Evaluation Modifications between the Beta-2 and Beta-3 Versions of ENDF/B-VII*

* Presentation for the Cross Section Evaluation Working Group meeting at Brookhaven National Laboratory, 6-8 November 2006

The solid red curve is final ENDF/B-VII after -0.2% correction for standards.

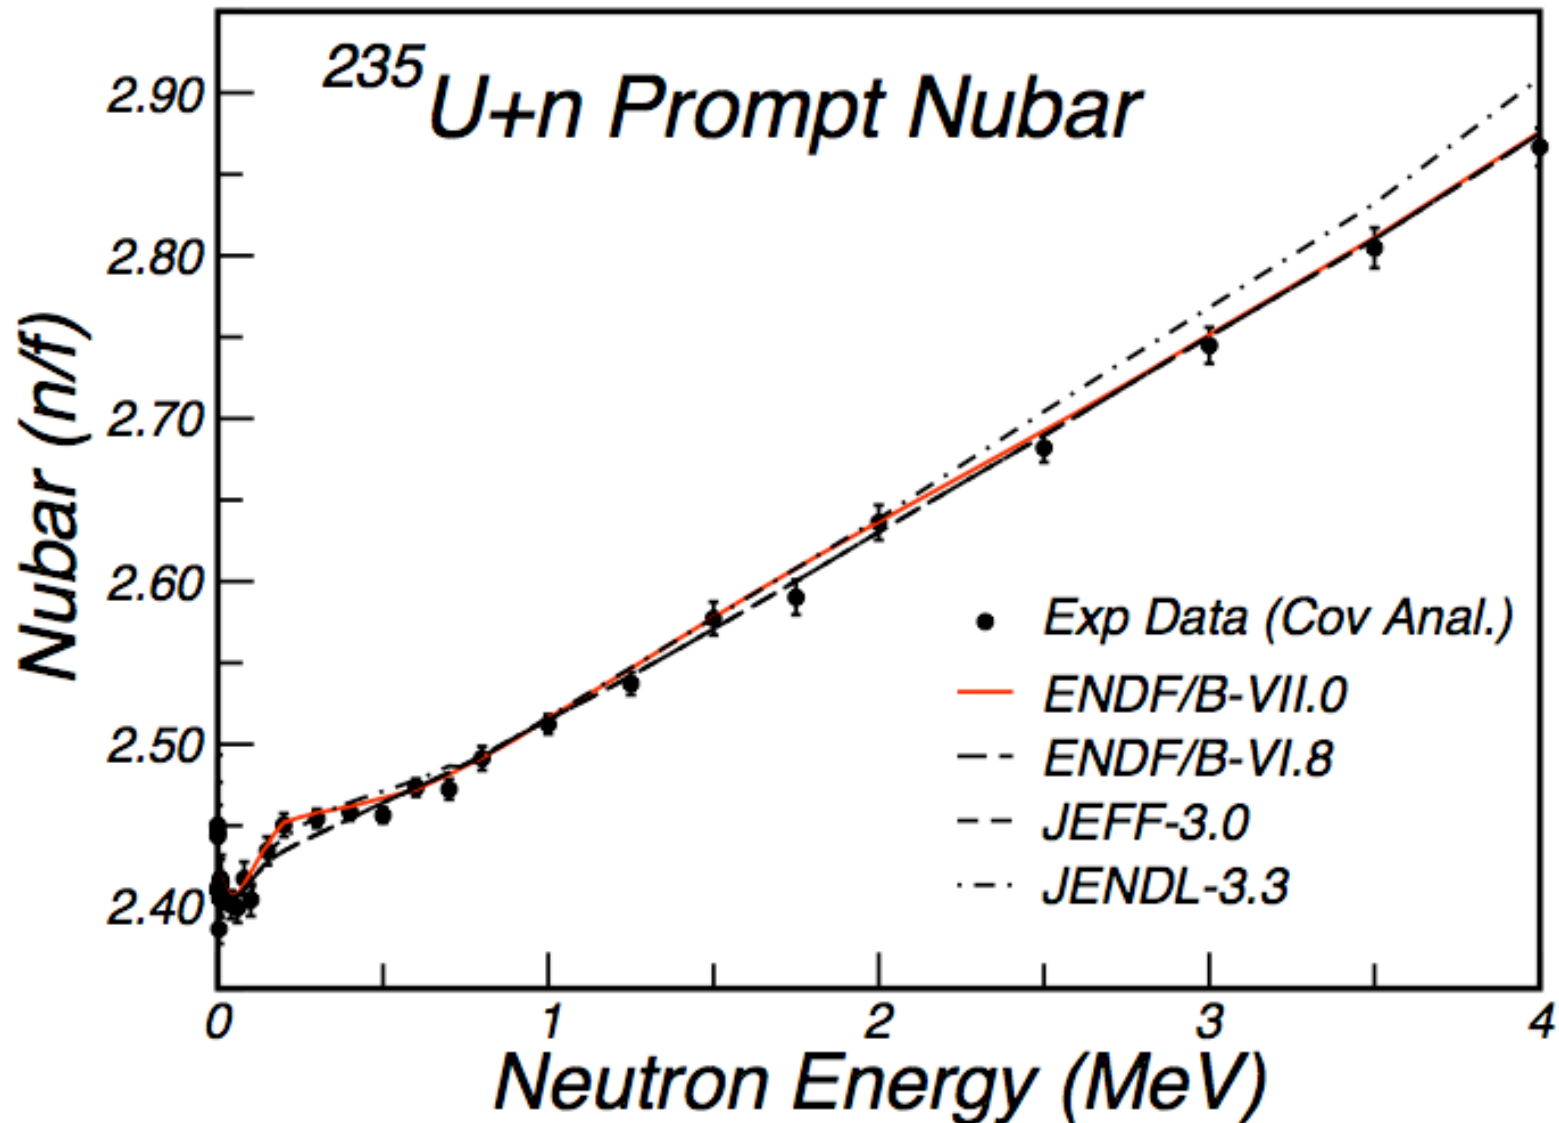
Updated and cleaned up the MF=1, MT=451 descriptive material. Modified nubar by -0.2% above 6 MeV to correct a normalization error in our nubar data base, caused by normalizing data to total rather than the prompt ^{252}Cf nubar standard. At lower energies the evaluations are based on generally matching the experimental data within uncertainties but with minor adjustments based on fast critical data. Thus the nubar data were left unchanged in the fission spectrum region ($E_n < 6$ MeV).
